#### 183rd session

## **Proposal for Supplement 1 to the original version of UN Regulation No. 154**

### **Submitted by the representatives of the European Commission and Japan \*, \*\***

"Figure 8/1

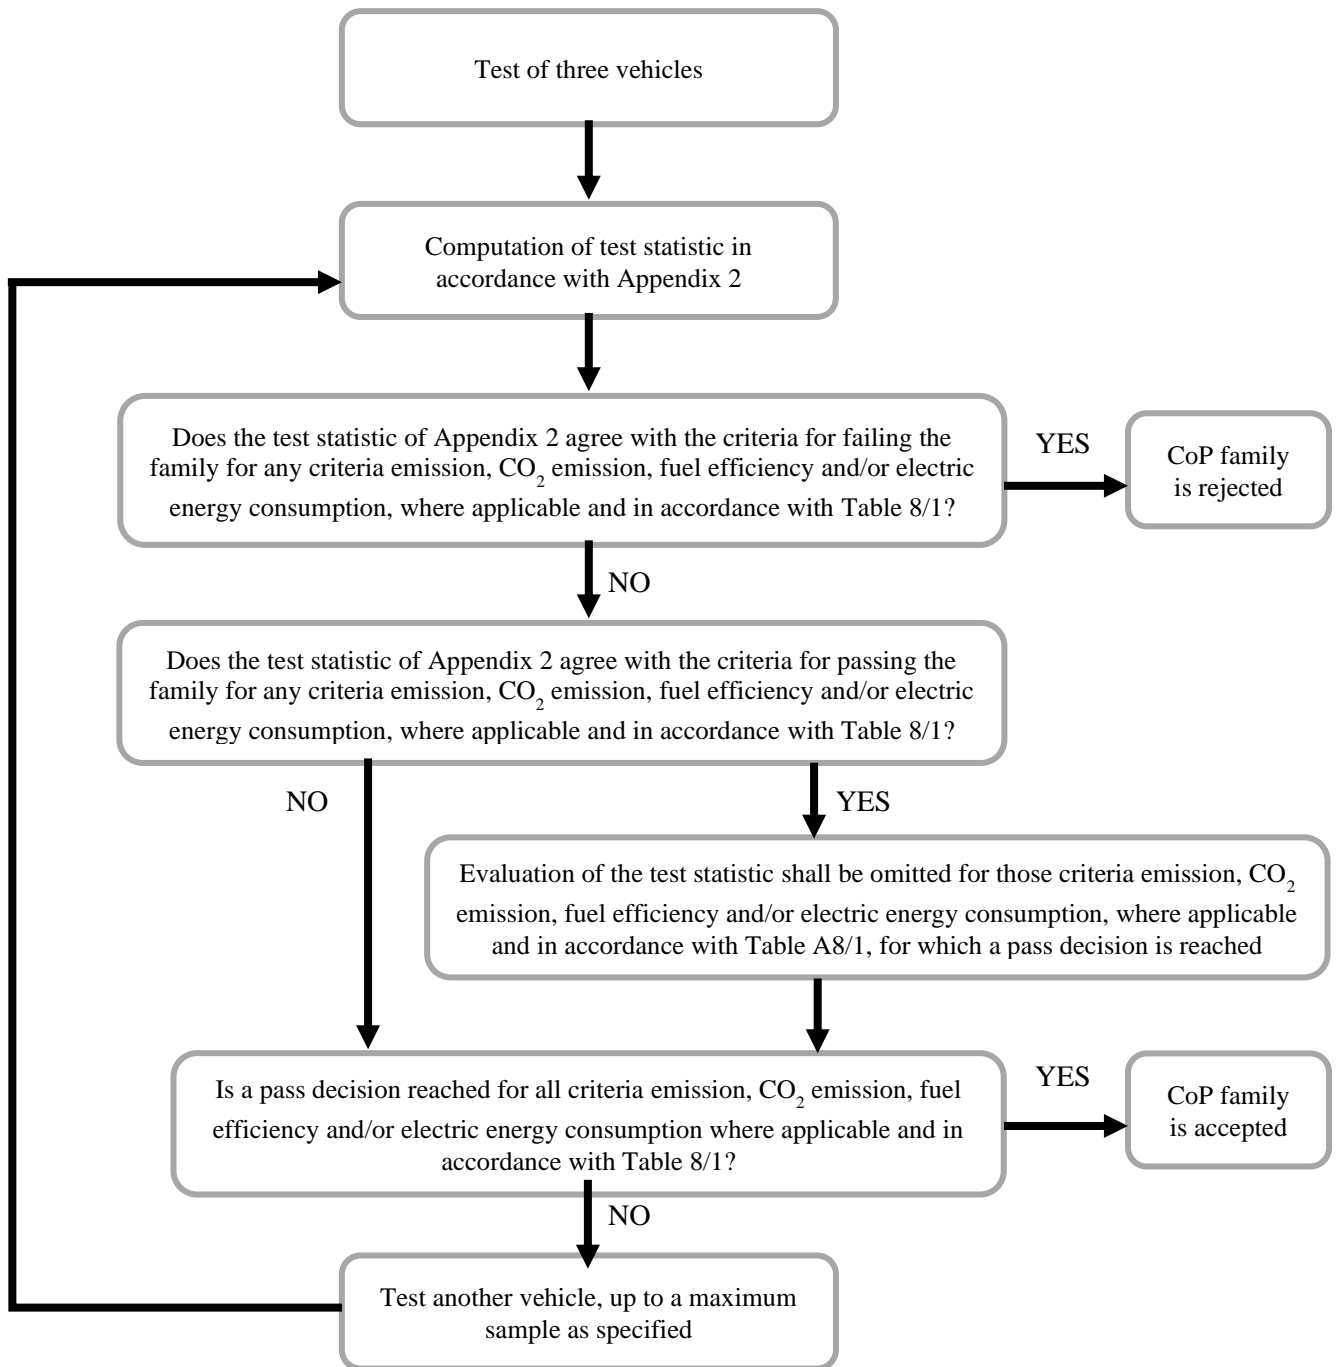
Paragraph 8.2.3.2., Figure 8/1, amend to read:

Figure A6/4

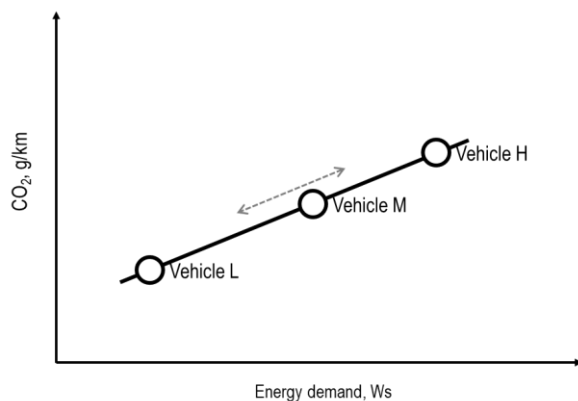
Paragraph 2.3.2.4., amend to read:

"2.3.2.4. Vehicle M is a vehicle within the interpolation family between the vehicles L and H with a cycle energy demand which is preferably closest to the average of vehicles L and H.

The limits of the selection of vehicle M (see Figure A6/4) are such that neither the difference in CO<sub>2</sub> emission values between vehicles H and M nor the difference in CO<sub>2</sub> emission values between vehicles M and L is greater than the allowed CO<sub>2</sub> range in accordance with paragraph 2.3.2.2. of this annex. The defined road load coefficients and the defined test mass shall be recorded.

Figure A8/2

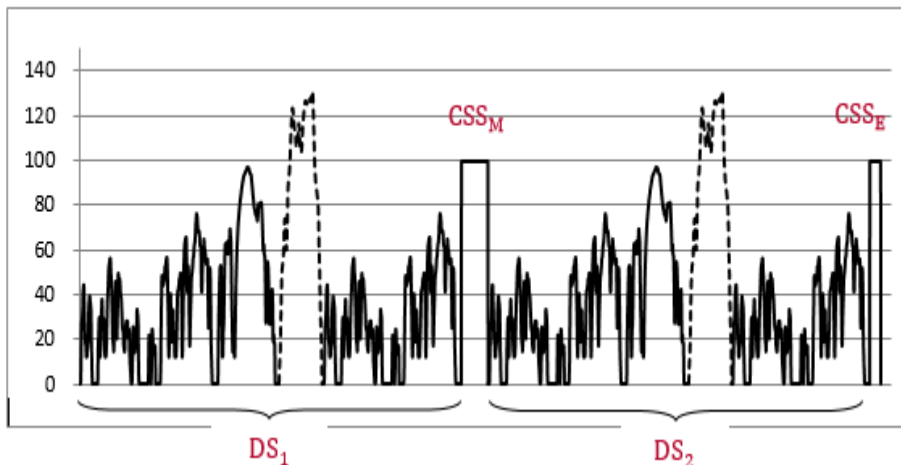
Paragraph 3.4.4.2.1., amend to read:

"3.4.4.2.1. Speed trace

The shortened Type 1 test procedure consists of two dynamic segments ( $DS_1$  and  $DS_2$ ) combined with two constant speed segments ( $CSS_M$  and  $CSS_E$ ) as shown in Figure A8/2.

Figure A8/5  
Limits for the selection of vehicle M

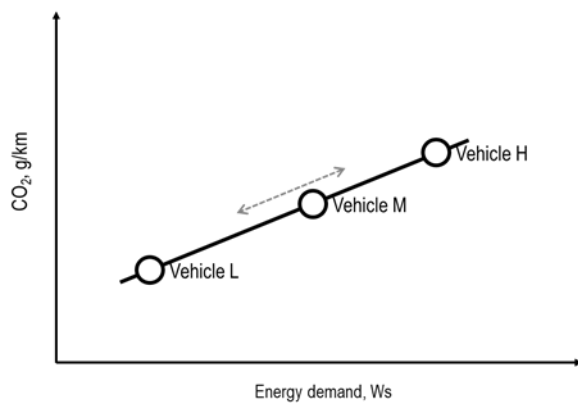
For Level 1A

The linearity of the corrected measured and averaged charge-sustaining CO<sub>2</sub> mass emission for vehicle M,  $M_{CO_2,c,6,M}$  according to step 6 of Table A8/5 of Annex B8, shall be verified against the linearly interpolated charge-sustaining CO<sub>2</sub> mass emission between vehicles L and H over the applicable cycle by using the corrected measured and averaged charge-sustaining CO<sub>2</sub> mass emission  $M_{CO_2,c,6,H}$  of vehicle H and  $M_{CO_2,c,6,L}$  of vehicle L, according to step 6 of Table A8/5 of Annex B8, for the linear CO<sub>2</sub> mass emission interpolation.
